Site Plan Reviewed
Wake County Inspections & Permits

As-Built Site Plan Required
Wake County Inspections & Permits

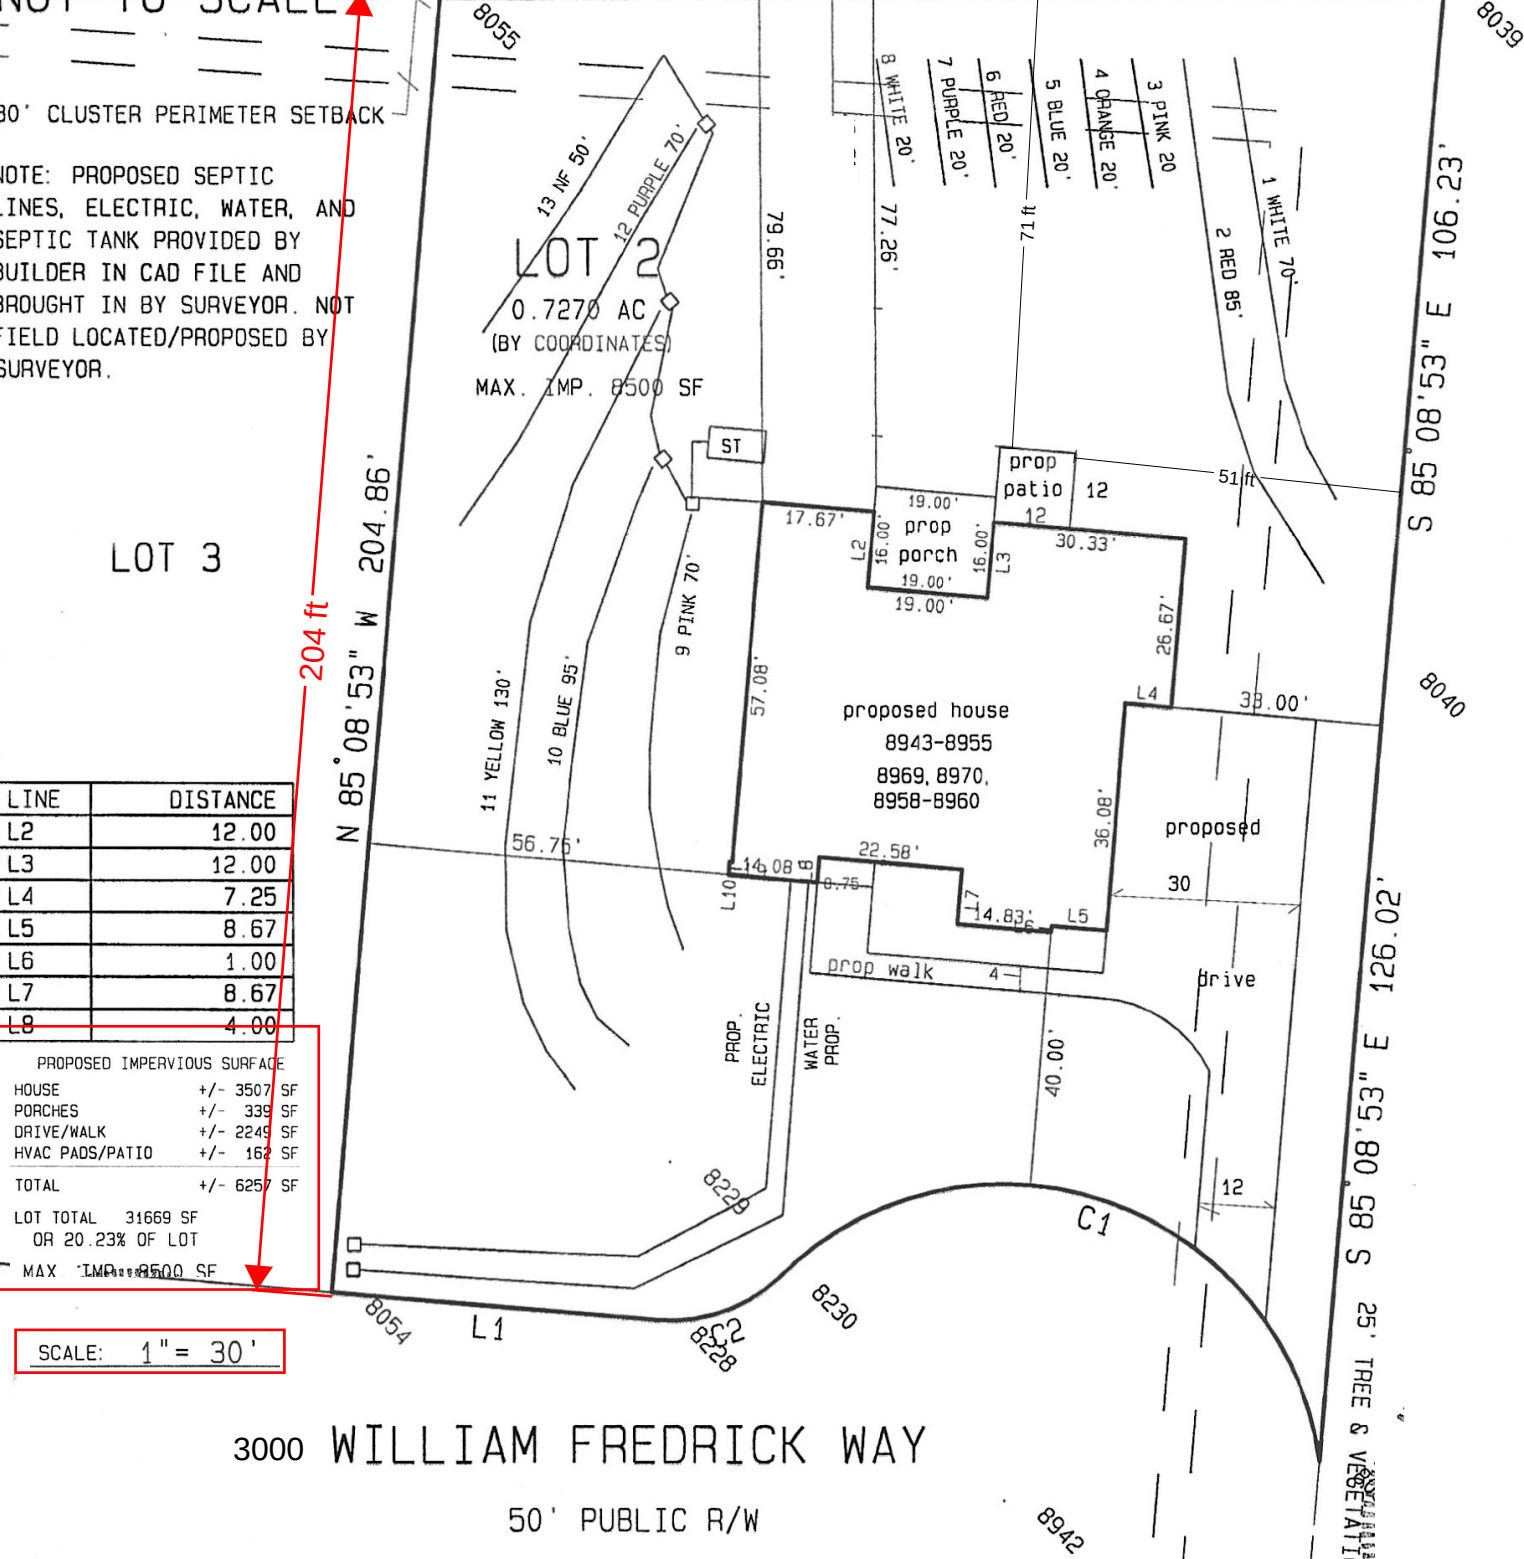
This review does not constitute an approval.
This site plan has been reviewed by Wake County Inspections & Permits Department for compliance with minimum permitting requirements. Additional site plan requirements, reviews and revisions may be required by other departments as part of the permitting process.

As-built surveys must be labeled as such and be completed by a professional land surveyor. The survey shall include all the required information as outlined in the Site Plan Submission Guidelines.
The date the as-built survey is prepared must be on or after the initial building final inspection.
